VILLAGE OF BARTLETT

Stearns Road/ RT. 59 IDOT Improvements

COMMUNITY DEVELOPMENT MEMORANDUM

RE: REVISED Rt. 59 and Stearns Road Intersection Improvements

Original Design Plan - Stearns Road East of Route 59 (Close-Up)

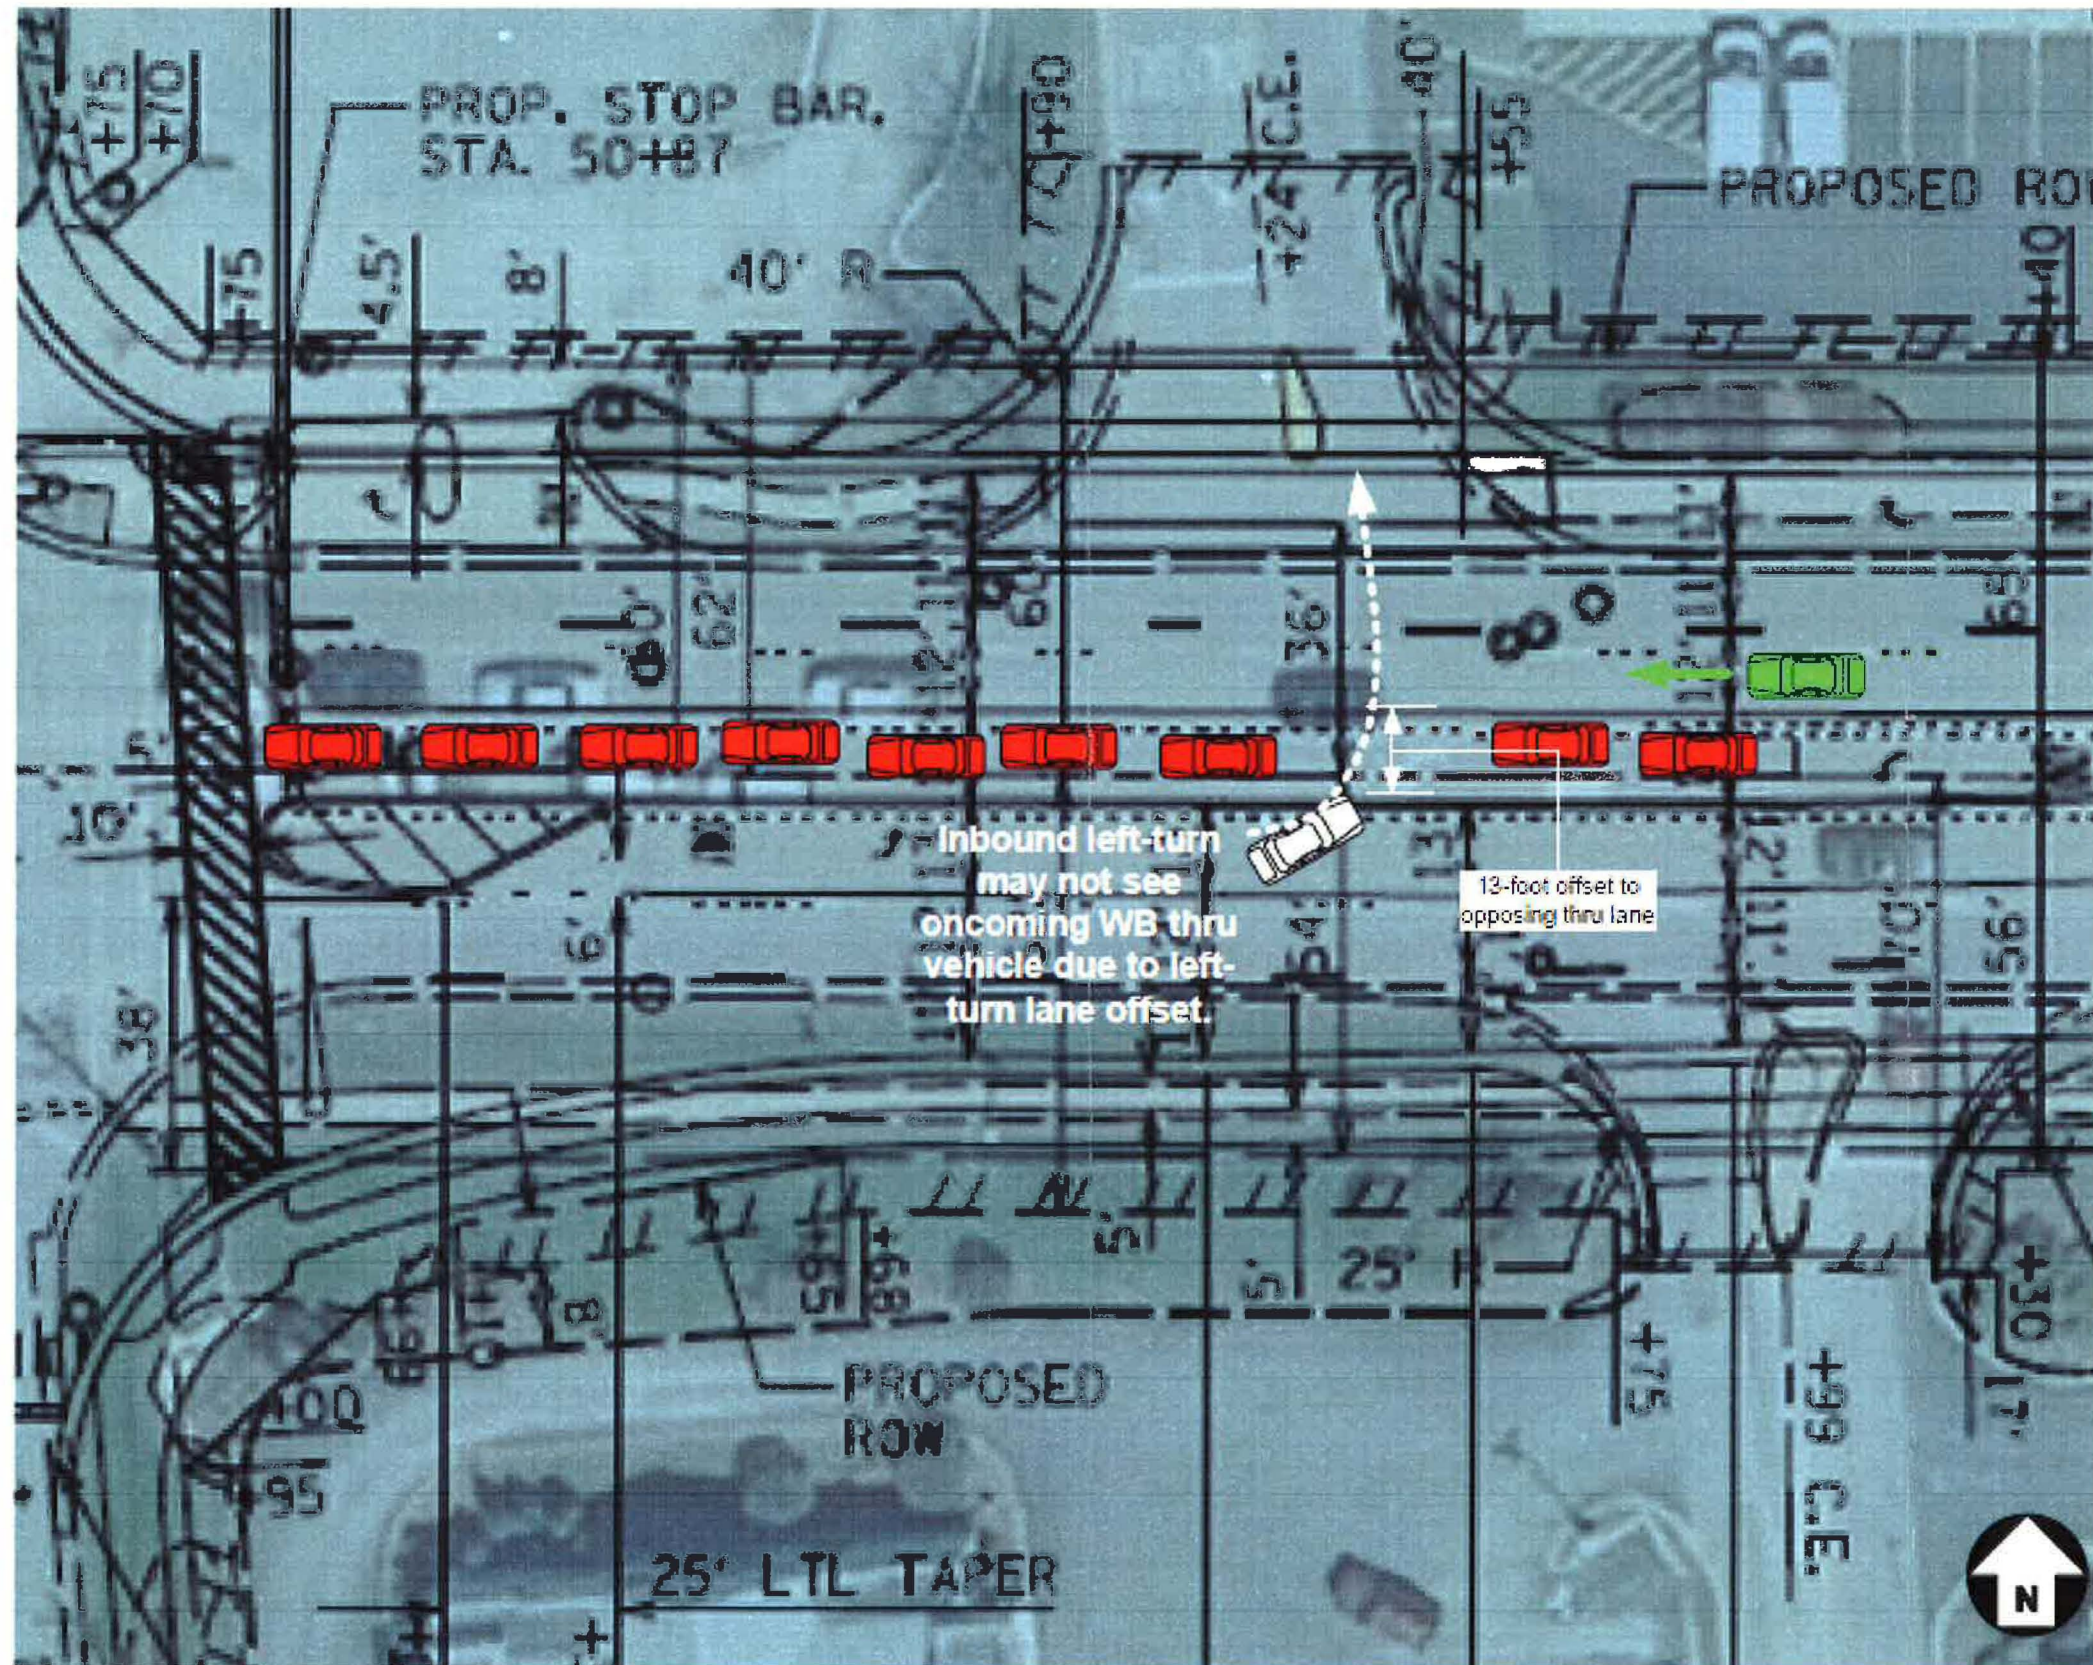
The proposed IDOT plans showed that the left turn from Stearns Road into the Brewster Creek Shopping Center would be eliminated and that access would be from the Rt. 59 entrances to the shopping center, Norwood Lane and westbound from Stearns Road with a right-in right-out access (see attached **Original Design** plan).
